RESOLUTION MSC.222(82)
(adopted on 8 December 2006)

**AMENDMENTS TO THE INTERNATIONAL CODE
OF SAFETY FOR HIGH-SPEED CRAFT, 2000**

Figure 2.6.7a

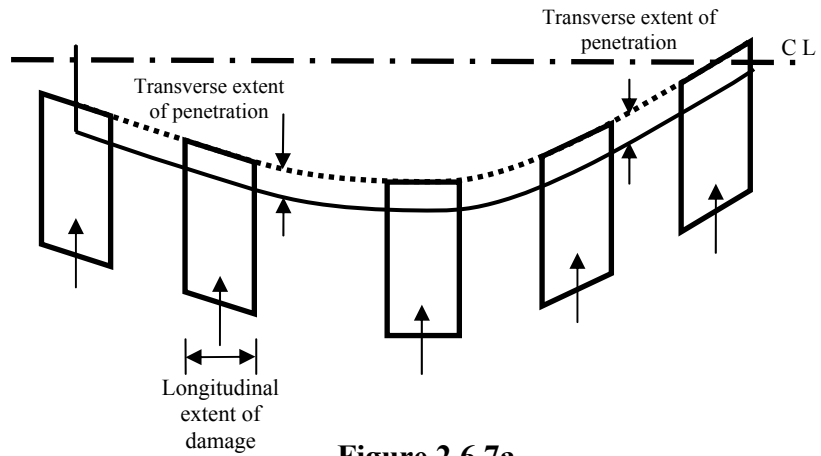
“The damages described in this paragraph shall be assumed to have the shape of a parallelepiped. Applying this to figure 2.6.7a, the inboard face at its mid-length shall be tangential to, or otherwise touching in a least 2 places, the surface corresponding to the specified transverse extent of penetration, as illustrated in figure 2.6.7a.

Figure 2.6.7b

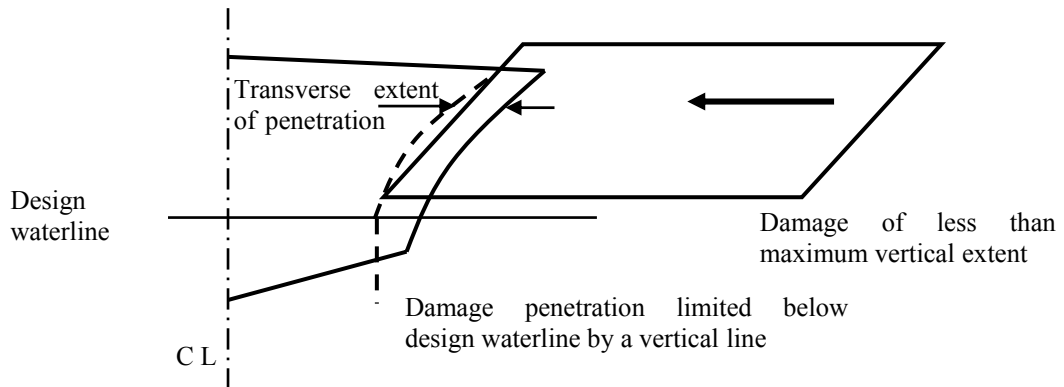
Side damage shall not transversely penetrate a greater distance than the extent of $0.2\nabla^{1/3}$ at the design waterline, except where a lesser extent is provided for in 2.6.7.2. Refer to figures 2.6.7b and 2.6.7c.

Figure 2.6.8”

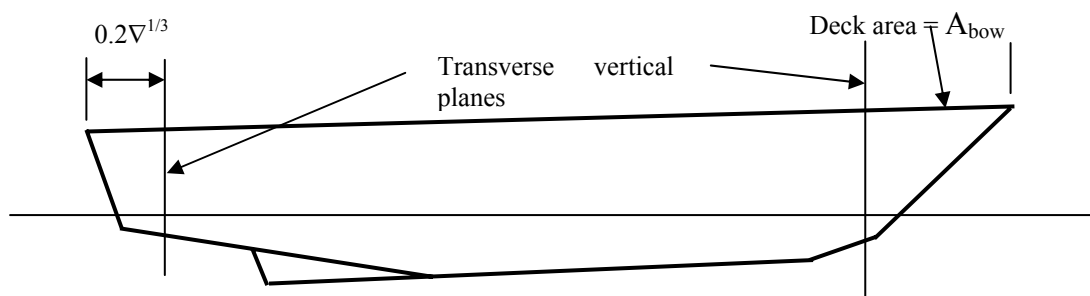
2.6.8.1 The following extents of damage are to be applied to bow and stern, as illustrated in figure 2.6.8:

- .1 at the fore end, damage to the area defined as A_{bow} in 4.4.1, the aft limit of which being a transverse vertical plane, provided that this area need not extend further aft from the forward extremity of the craft's watertight envelope than the distance defined in 2.6.7.1; and
- .2 at the aft end, damage to the area aft of a transverse vertical plane at a distance $0.2\nabla^{1/3}$ forward of the aft extremity of the watertight envelope of the hull.

Figure 2.6.9.2”

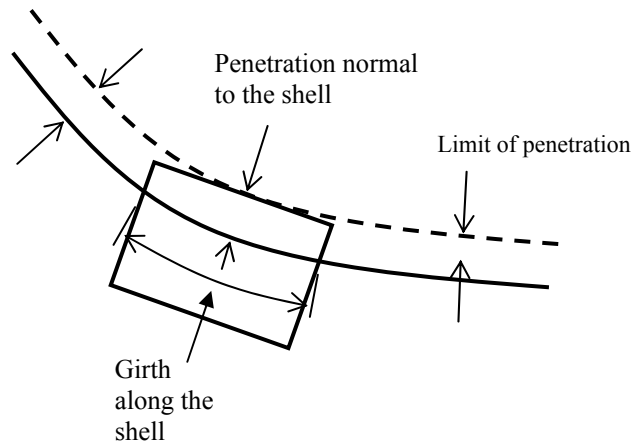
“2.6.9.2.3 The shape of damage shall be assumed to be rectangular in the transverse plane as illustrated in figure 2.6.9.2 below. Damage is to be assumed at a series of sections within the defined longitudinal extent in accordance with figure 2.6.9.2, the mid-point of the damaged girth being maintained at a constant distance from the centreline throughout that longitudinal extent.

“.4 the shape of damage shall be assumed to be rectangular in the plane of the shell of the craft, and rectangular in the transverse plane as illustrated in figure 2.6.9.2.”

Figure 7.3.4a

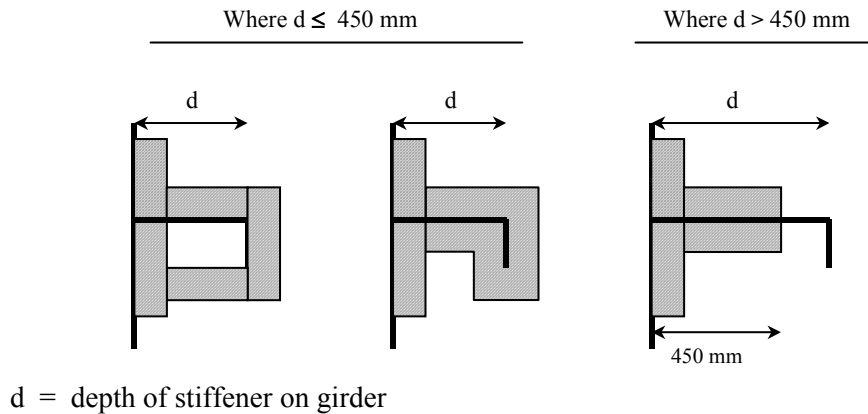
“7.3.4 To prevent heat transmission at intersections and terminal points, the insulation of the deck or bulkhead shall be carried past the intersection or terminal point for a distance of at least 450 mm in the case of steel or aluminium structures (refer to figures 7.3.4a and 7.3.4b).

Figure 7.3.6

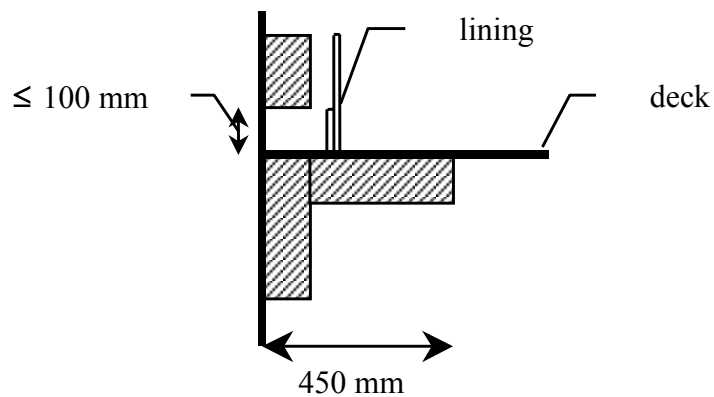
7.3.6 Where the lower part of the fire insulation has to be cut for drainage, the construction shall be in accordance with the structural details shown in figure 7.3.6.
